Work Order ID 75902

Item Name: Float Skidtube Installation

# DART SERVICE INSTRUCTION

TO AMEND INSTALLATION INSTRUCTIONS IIN-D412-742 REV. D  
AND INSTRUCTIONS FOR CONTINUED AIRWORTHINESS ICA-D412-742 REV. 3

**FIGURE 1: CHANGE AT FORWARD SADDLE LOCATION  
WITH DSI-9517-011 KIT INSTALLED**

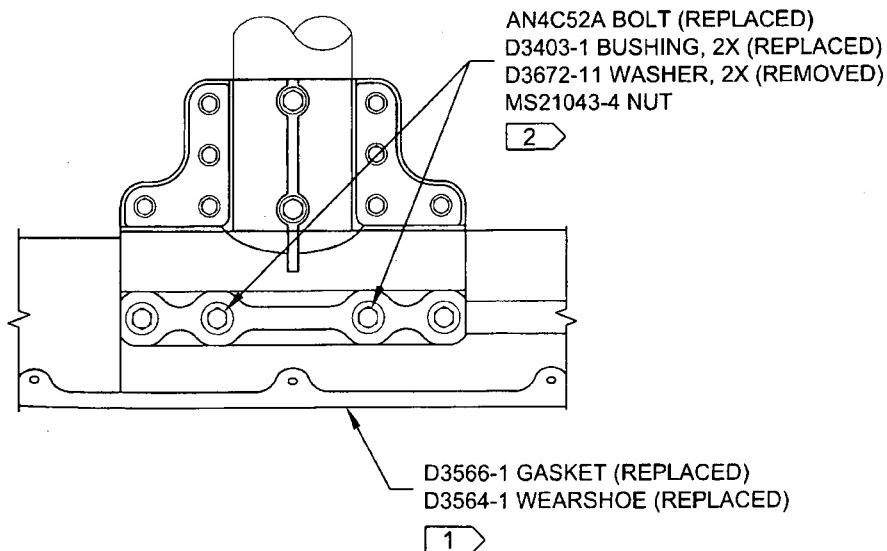
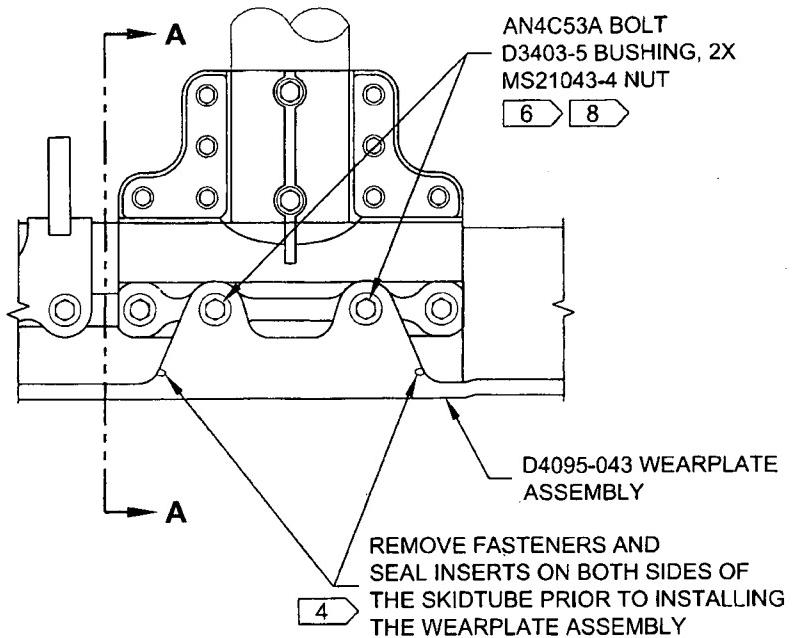
The purpose of this service instruction is to introduce an alternate wearplate installation for the D412-742-011/-013 Skidtube Installations. The new DSI-9517-011 Wearplate Kit consists of new wearplates destined to replace existing D3564-1/-3 Wearshoes and D3566-1/-3 Gaskets. The components in the DSI-9517-011 Wearplate Kit are as defined in the parts list on sheet 4 of this service instruction.

- Replace D3564-1/-3 Wearshoes and D3566-1/-3 Gaskets with D4095-041/-043 Wearplates Assemblies as follows:
1. Remove existing D3564-1/-3 Wearshoes and D3566-1/-3 Gaskets per Item 32.6.1 of ICA-D412-742. It might be necessary to loosen the aft end of D3564-5 Wearshoe and D3566-5 Gasket.

2. Remove qty.(4) AN4C52A Bolts, D3403-1 Bushings, and qty.(8) D3672-11 Washers as indicated in Figures 1 and 2 of this service instruction.
  3. Inspect the skidtube and saddles per Chapter 5 of ICA-D412-742.

4. Seal existing inserts located on both sides of the skidtube in area shown in Figures 1 and 2 of this service instruction using Sikaflex -241/-291 or Proseal 890 or MIL-S-8802 Class 2B sealant.

5. Locate the DSI-9517-011 Wearplate Kit as shown in Figure 1 and 2 of this service instruction.
  6. Transfer drill qty.(2) Ø0.438 hole from the skidtube/saddle to the D4095-041/-043 Wearplates Assemblies. Deburr. Touch up finish per Item 5.2.14 of ICA-D412-742 as required.

7. Install the DSI-9517-011 Wearplate Kit using the same AN3C hardware as shown in ICA-D412-742. Torque to 15-25 in-lbs (1.7-2.8 N-m).
  8. Install D3403-5 Bushings and AN4C53A Bolts in lieu of D3403-1 Bushings and AN4C52A Bolts removed at step 2 above. Ensure that the nuts on the AN4C Bolts are on the inboard side of the skidtube. Torque to 50-70 in-lbs (5.7-7.9 N-m).
